**STATE SIGNIFICANT DEVELOPMENT APPLICATION – 8669
ST ALOYSIUS' COLLEGE – CONCEPT APPROVAL AND STAGE 1 BUILT FORM APPROVAL**

St Aloysius' College – SSDA 8669

Independent Planning Commission

1 Plan - Roof
Scale: 1:200

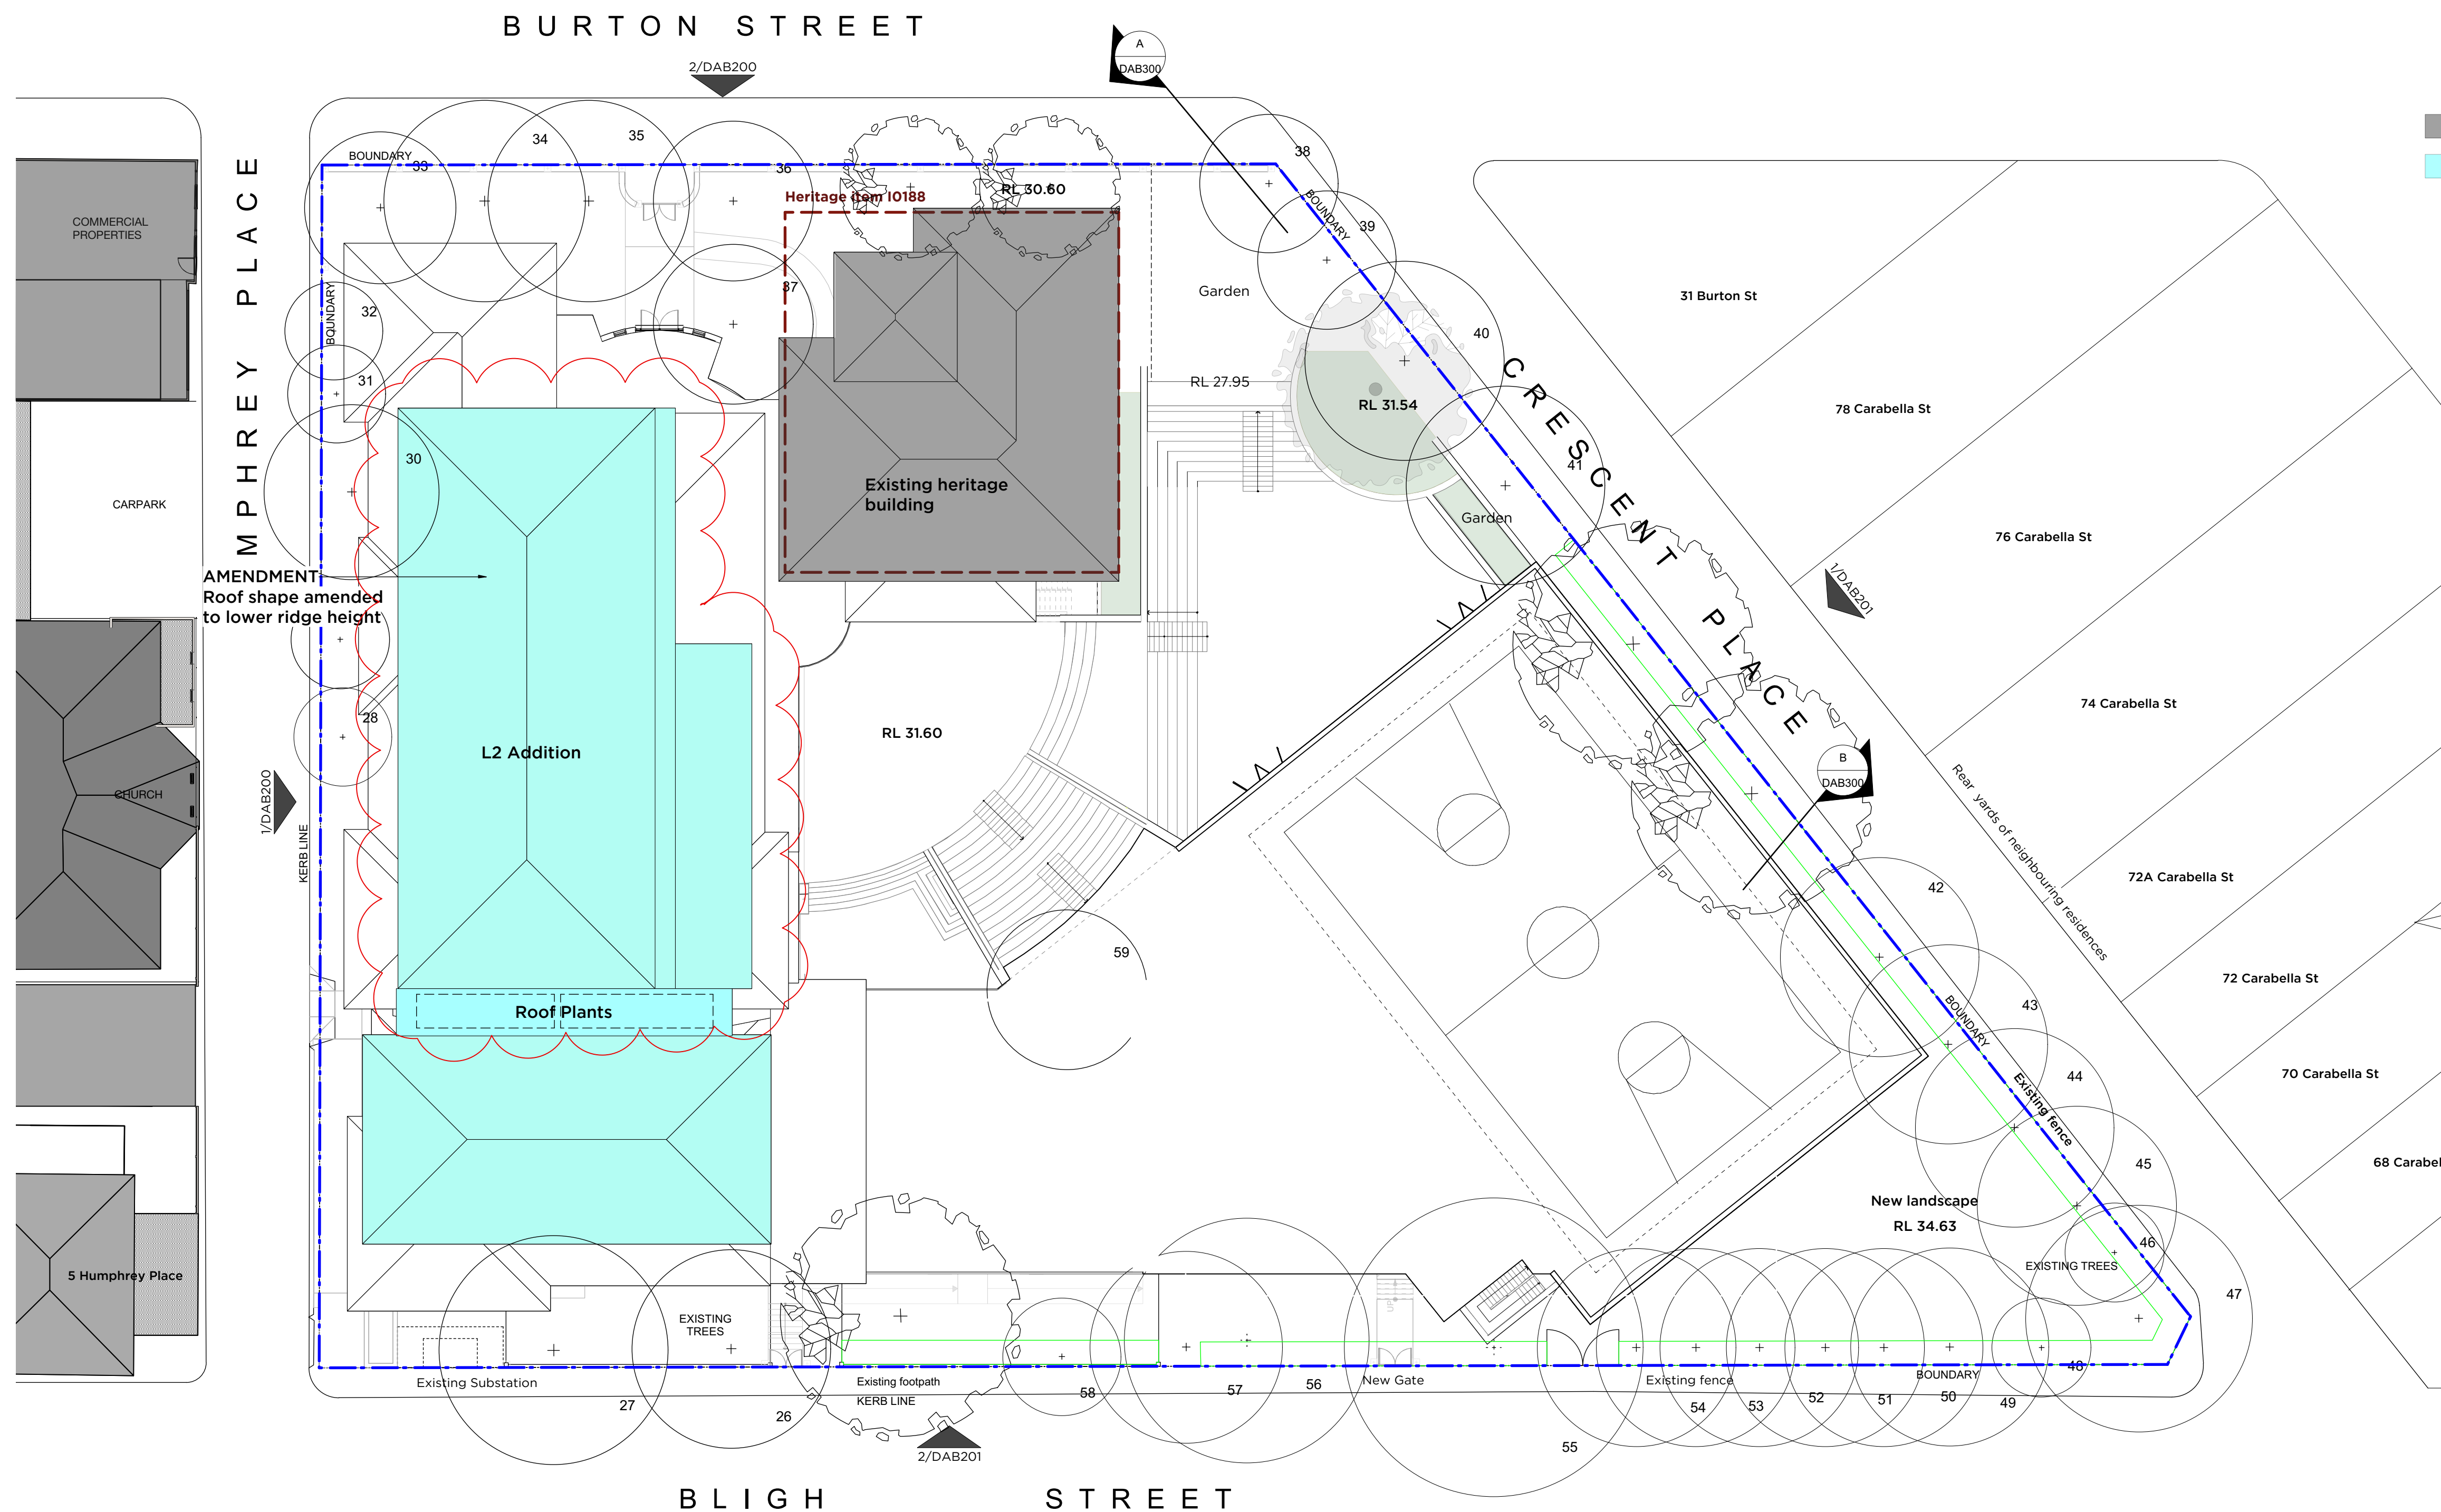
<ul style="list-style-type: none"> ▪ Provide sketch of alternative roof form for Junior Campus addition. 	<p>The roof form of the Junior Campus addition has been amended to present as a hip roof, reducing the height of the ridge line of the new addition. A maximum RL 43.60 is exhibited, which continues to sit below the maximum height of the existing heritage item being RL 45.09, which will continue to promote the heritage items of the Junior Campus.</p> <p>Refer to Appendix B, Drawing No. DAB200D, DAB201D and DAB300D.</p>
<ul style="list-style-type: none"> ▪ Clarify maximum RL height of Junior Campus. 	<p>Refer to Appendix B, Drawing No. DAB124.</p> <p>The architectural drawings were reviewed and there was a discrepancy with the RL identified at the corner of Bligh Street and Crescent Place (RL36.55). Our review indicates that this point has an estimated RL 34.20. It is noted the survey documentation does not show this exact location.</p> <p>Notwithstanding, the architectural drawings have been amended to reflect the revised RL. Detailed survey will be obtained during detailed design. All other RL's are correct.</p>

6 Shadow Diagram 3pm June 21st
Scale: 1:500

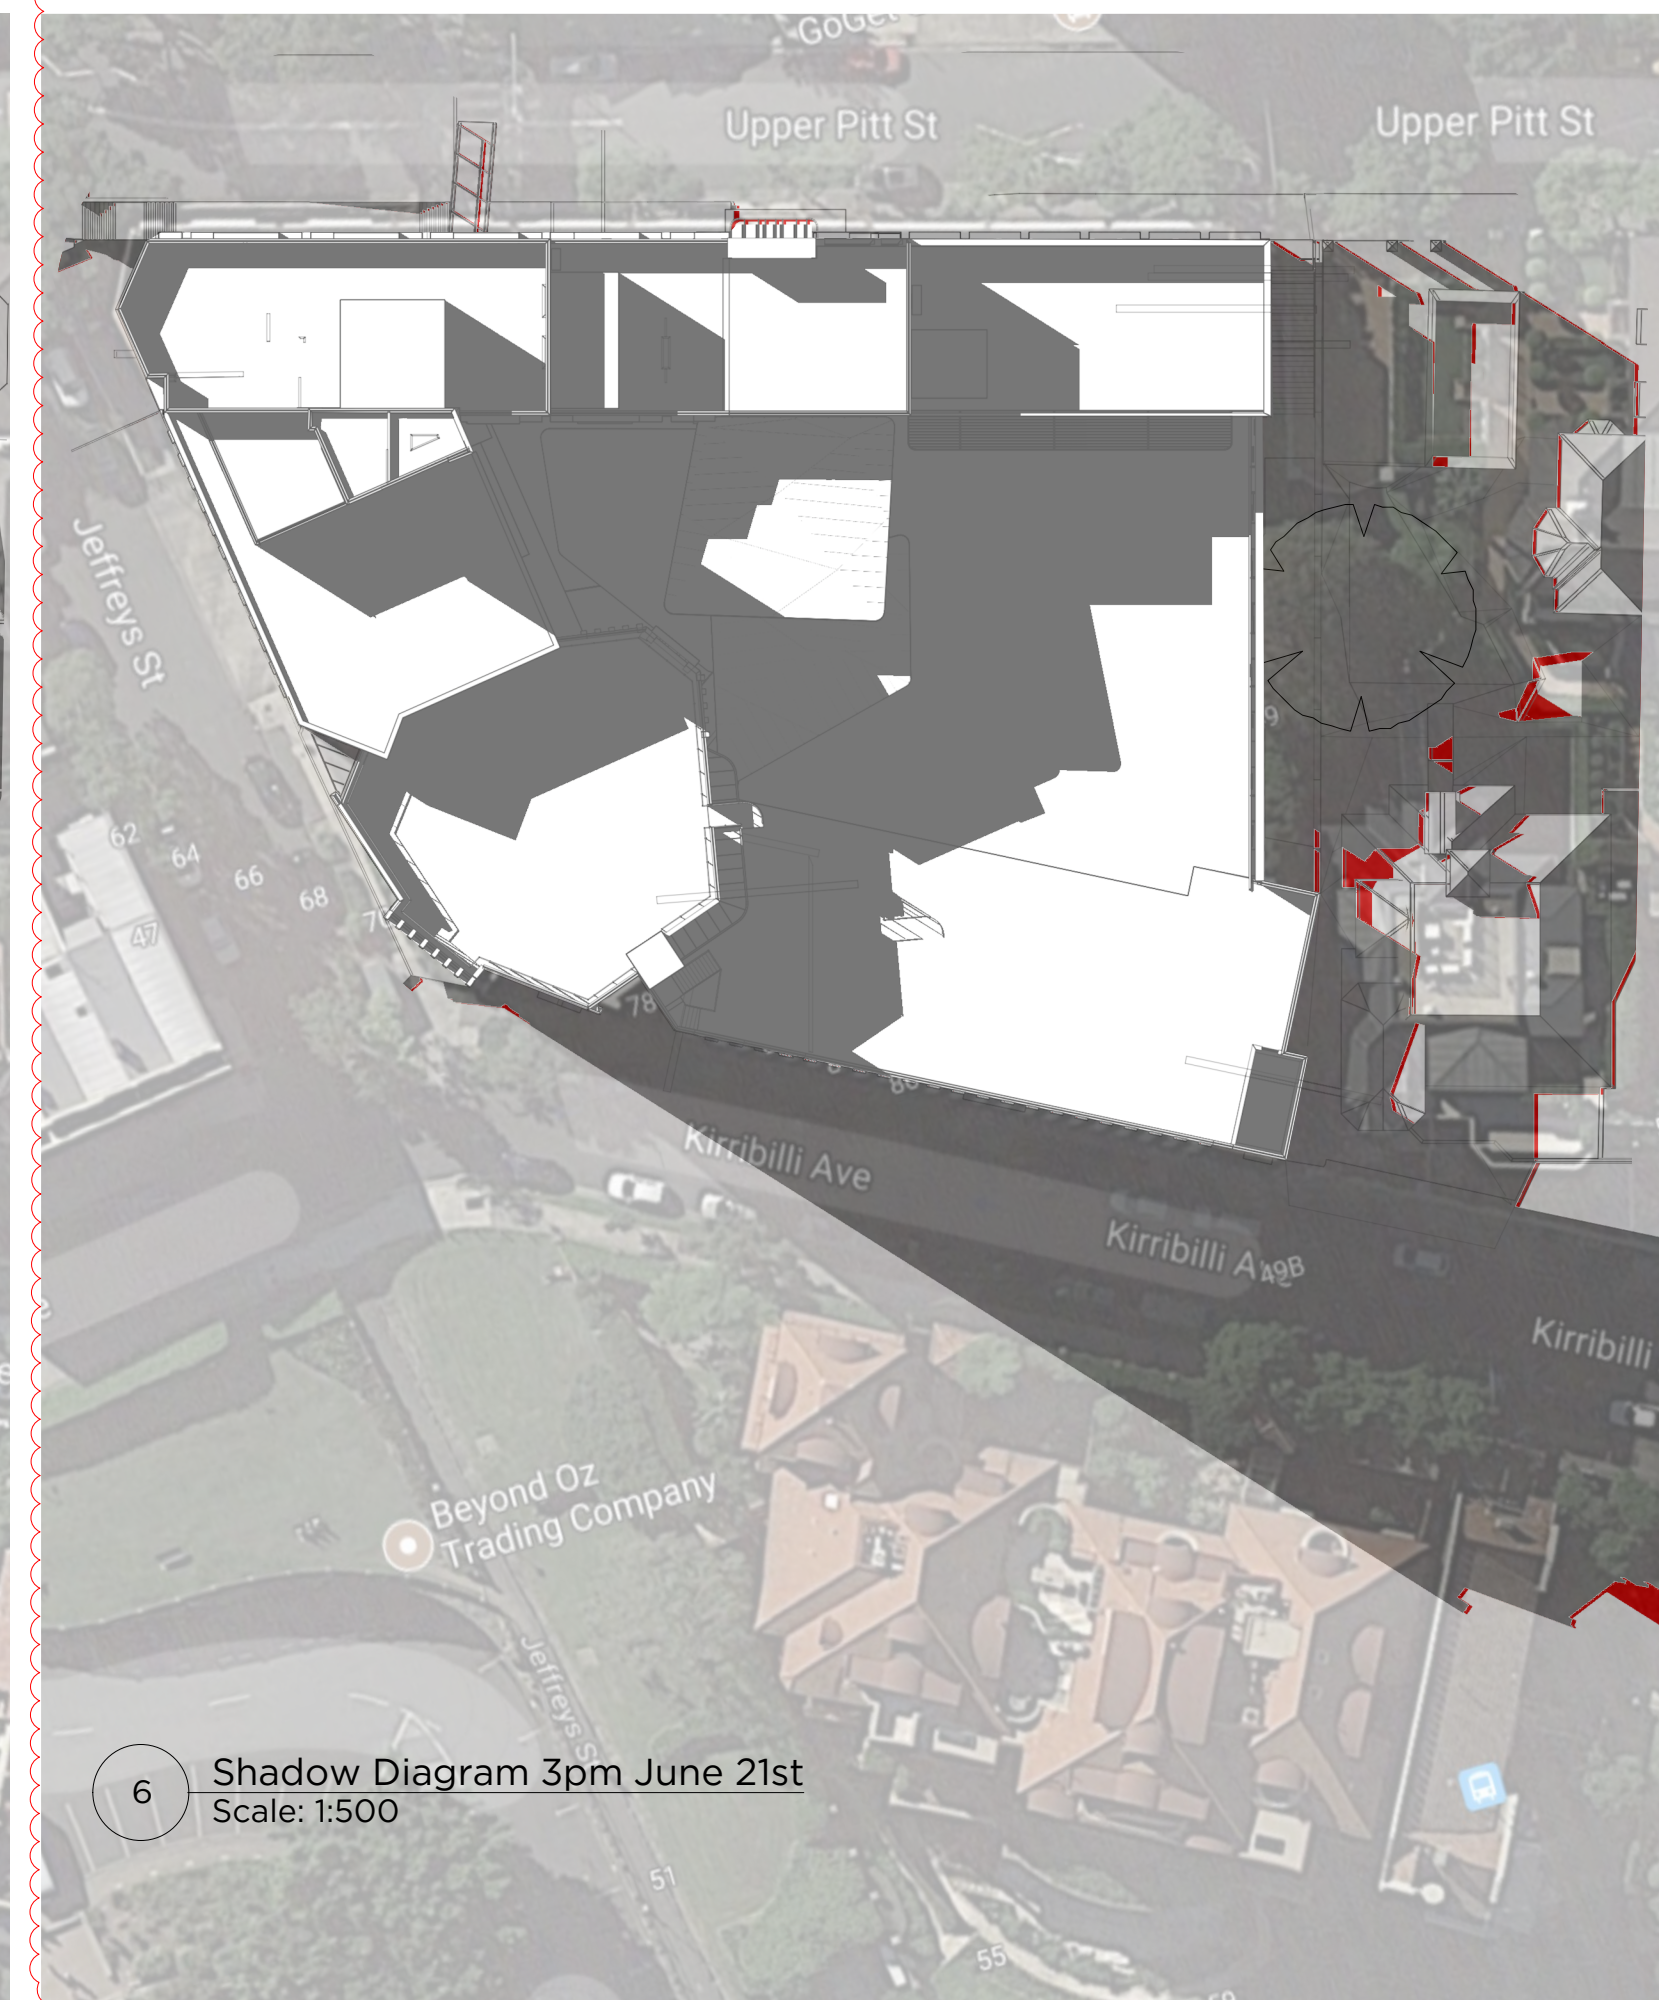
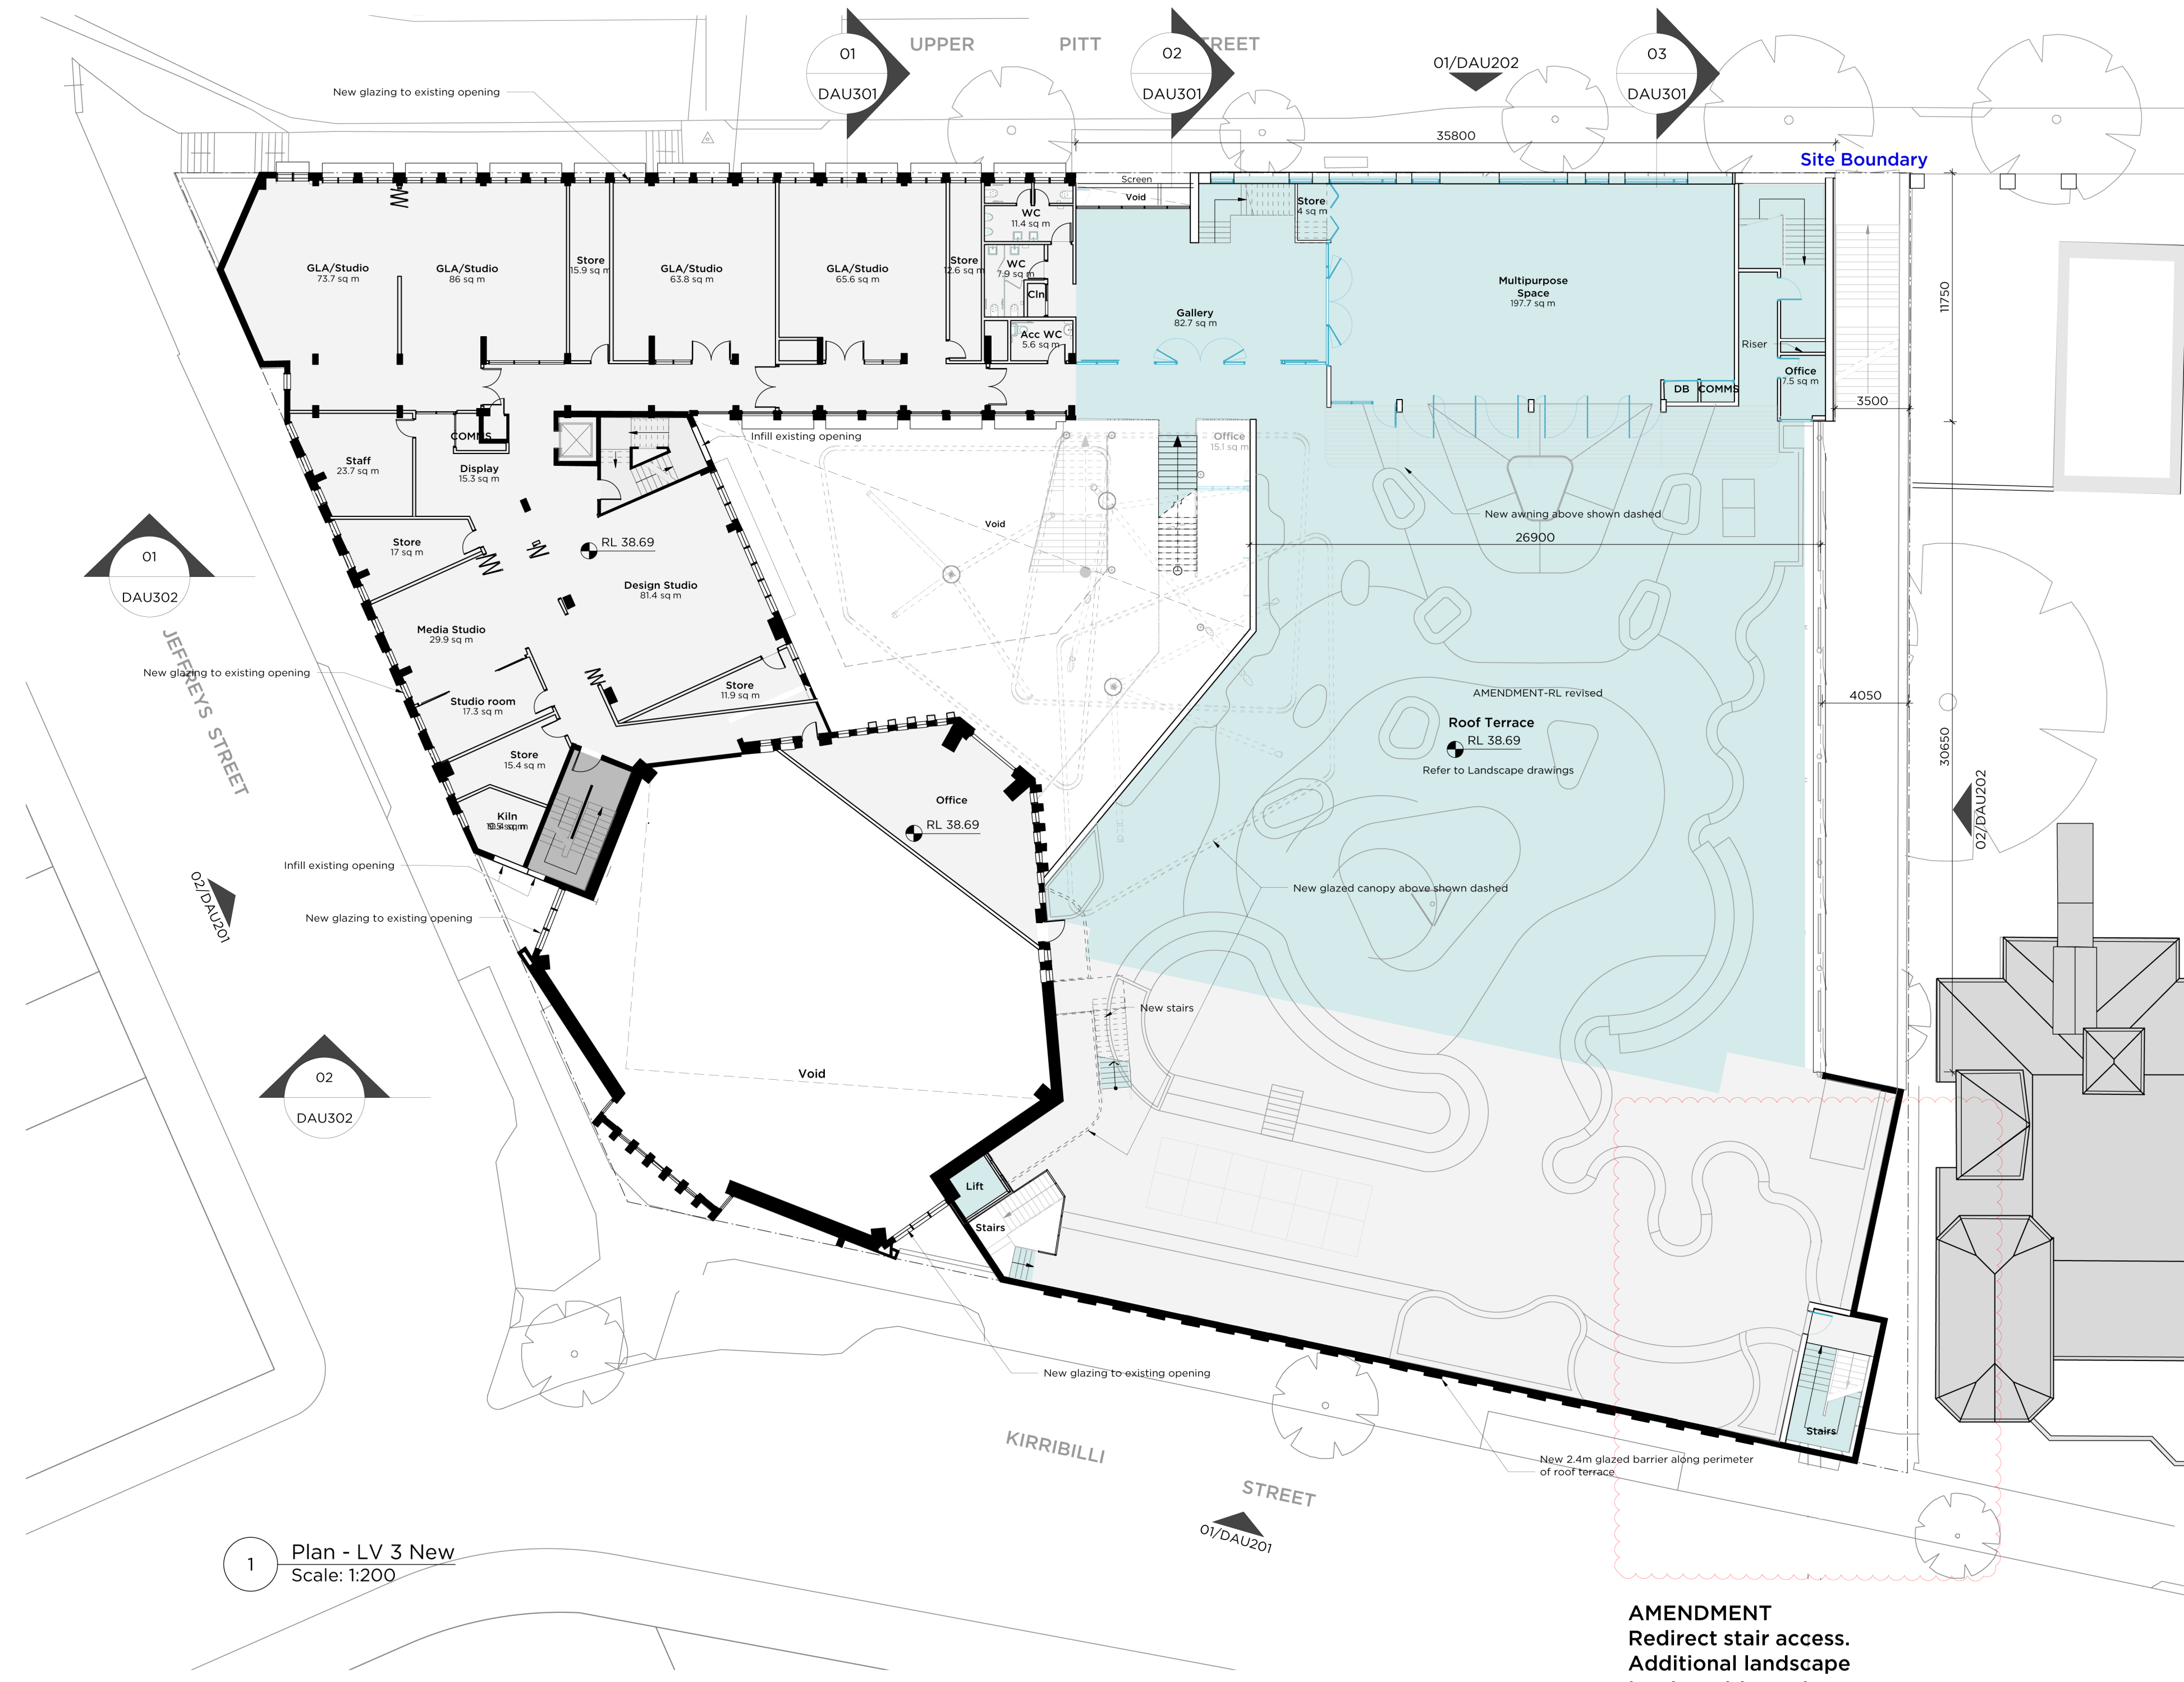
<ul style="list-style-type: none"> Reproduce 3pm winter shadow diagrams for the existing built form and the proposed infill development. 	<p>Refer to Appendix B.</p> <p>The shadow diagrams have been updated (Drawing No. DAU020D). The updated diagrams confirm the shadow diagrams are correct and consistent with RobertsDay Solar Analysis Report, as previously submitted to the Department of Planning, Industry and Environment.</p> <p>As noted on Drawing No. DAU020D, there is minimal additional overshadowing on the neighbouring property to the east (49 Upper Pitt Street). The primary overshadowing of the property is on the vertical surface, which has been captured in the RobertsDay Assessment.</p>
<ul style="list-style-type: none"> Provide specific areas of the motor/ plant rooms. 	<p>Refer to Appendix B. Amended Drawing No. DAU130F illustrates all plant enclosures and modifications proposed.</p>

AMENDMENT
Existing tree shadow
removed for
diagrammatic purposes.
Shadow Diagram is
correct and is consistent
with Robertsday's Solar
Analysis Report
